INSTALLATION AND OPERATING INSTRUCTIONS

TYPE 1261-A POWER SUPPLY

Form 649-A

GENERAL RADIO COMPANY
CAMBRIDGE 39, MASSACHUSETTS

FIG. 1.2

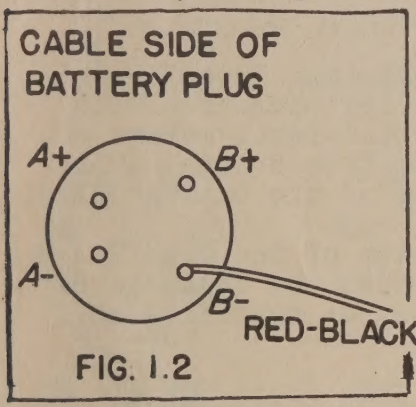
1.2 Installation: Remove large battery clamp from battery cable of Type 759-A. Connect battery plug to battery cable as follows (See Figure 1.2):

(a) Connect slate lead to B+ prong of plug.

(b) Connect black lead and black-yellow lead to A- prong of plug.

(c) Connect red lead and red-yellow lead to A+ prong of plug.

(d) Connect red-black lead, furnished in kit of parts, between B- terminal of battery plug and terminal No. 1 of socket for T-6 in Type 759-A.

FIG. 2.1

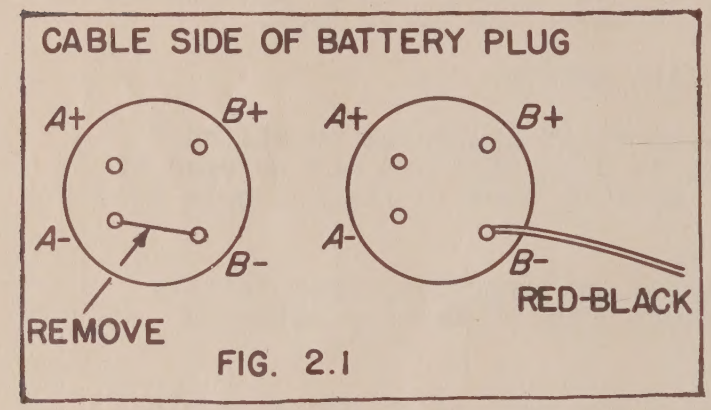
2.1 Remove jumper between A- and B- terminals (shown in A above) and connect red-black lead from B- terminal on battery plug to terminal No. 2 of socket for V-3 as indicated in B above.

FIG. 3.3

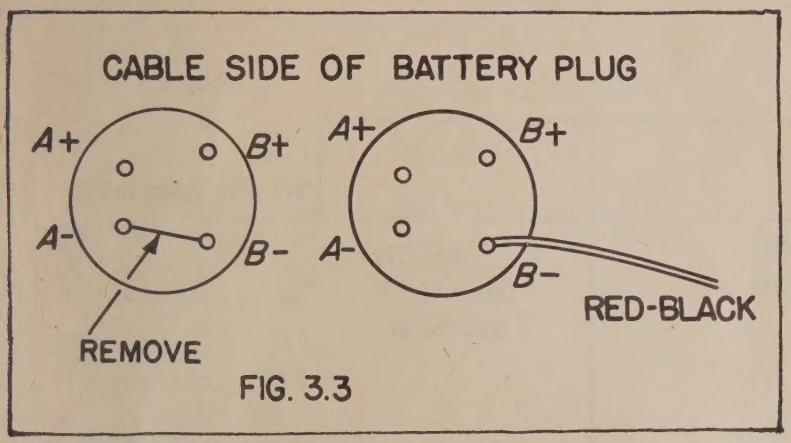
3.3 Remove jumper between A- and B- terminals of battery plug (indicated in Figure 3.3 above). Add red-black lead connecting B- terminal of battery plug to anchor terminal, in the Type 720-A, which is located just above the ON-OFF switch and is connected to switch with red lead.

FIG. 4.2

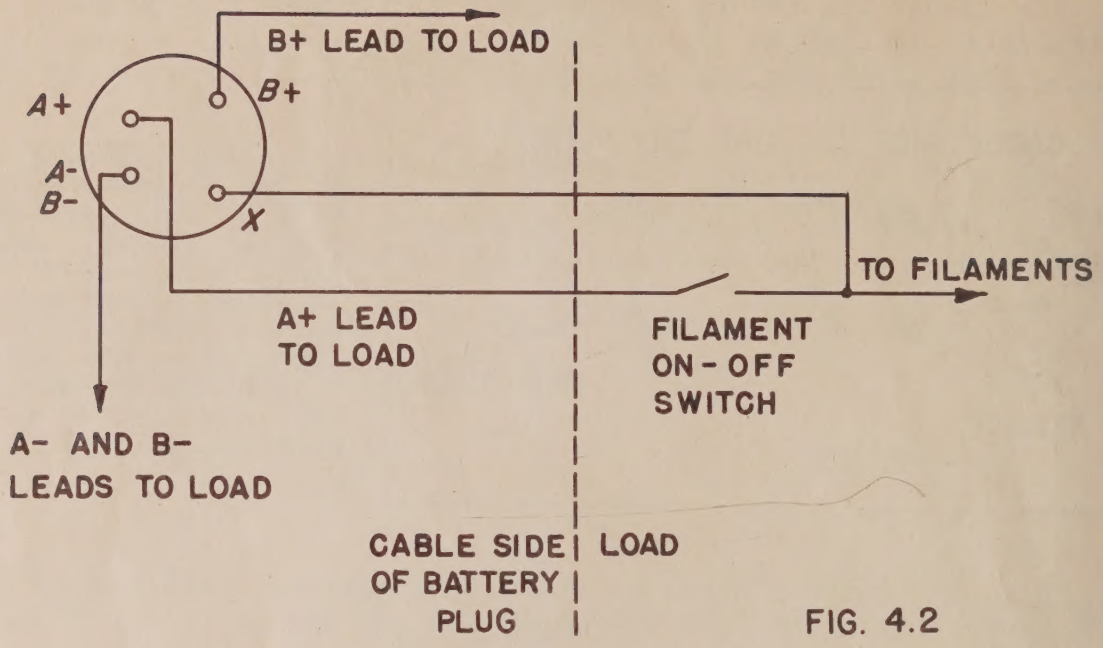
4.2 The battery plug should be wired as shown in Figure 4.2 when for general use to replace batteries.

4.3 It will be noted that the normal B- terminal of the battery plug is labeled X and is connected to A+ on the load side of the ON-OFF switch. This connection is made so that the flashlight cells which float across the output of the filament supply are protected at all times. B- connection to the instrument is usually ground as is the A- connection so that the two are tied together and to the A- terminal on the battery plug. This puts B- of the battery at A+ potential when the same plug is again used with a battery, but this causes no difficulty.

Figure 1.1

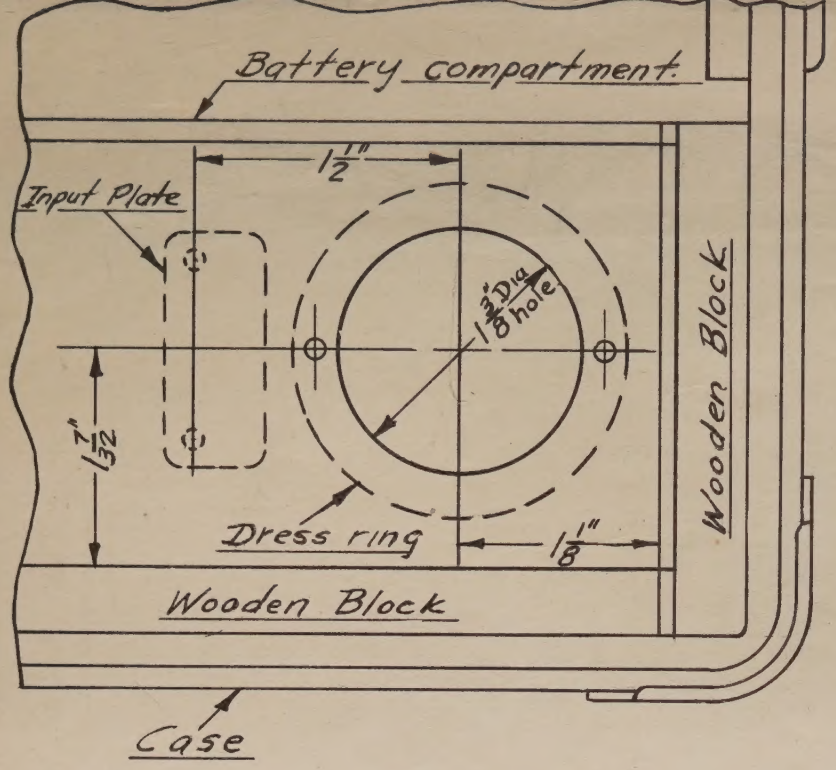
1.1 Cut hole in bottom of cabinet as indicated on attached drawing, Figure 1.1. This drawing is full size and may be used as a template for cutting the hole. A dress ring to fit the hole is included in the kit of parts.

Locate and drill 1 3/8" dia. hole as shown

Fasten Dress ring with #3 round head wood screw 3/16" long to bottom of case.

Figure 3.1

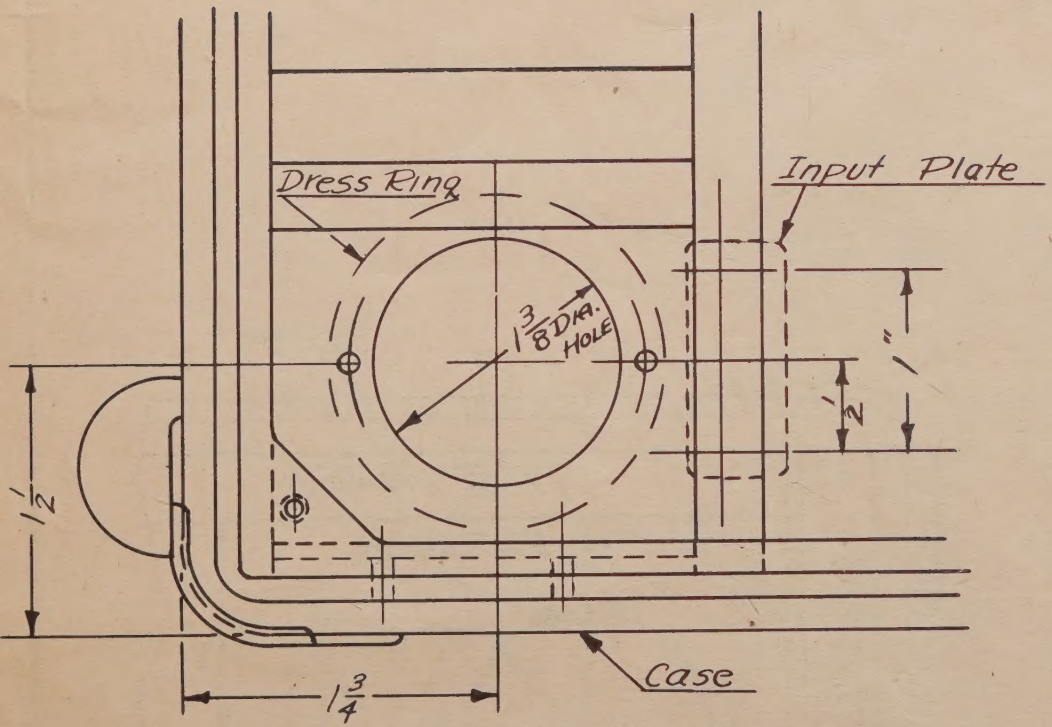
3.1 Cut hole in bottom of cabinet as indicated on attached drawing, Figure 3.1. This drawing may be used as a template for cutting the hole. Dress ring to fit hole is included in the kit of parts. Sponge rubber pieces 1/8" thick are also provided to replace the present pieces which are 1/4" thick, thus making it possible to clamp the power supply into the battery compartment with the cast-aluminum battery clamp.

Figure 3.2

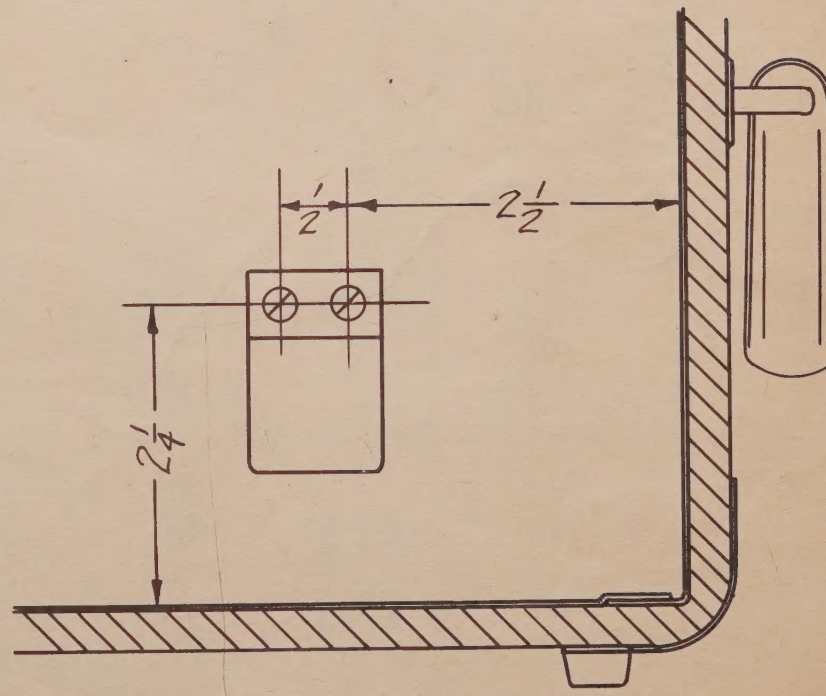
3.2 Mount the two grounding springs in sides of cabinet as illustrated in drawing of Figure 3.2.
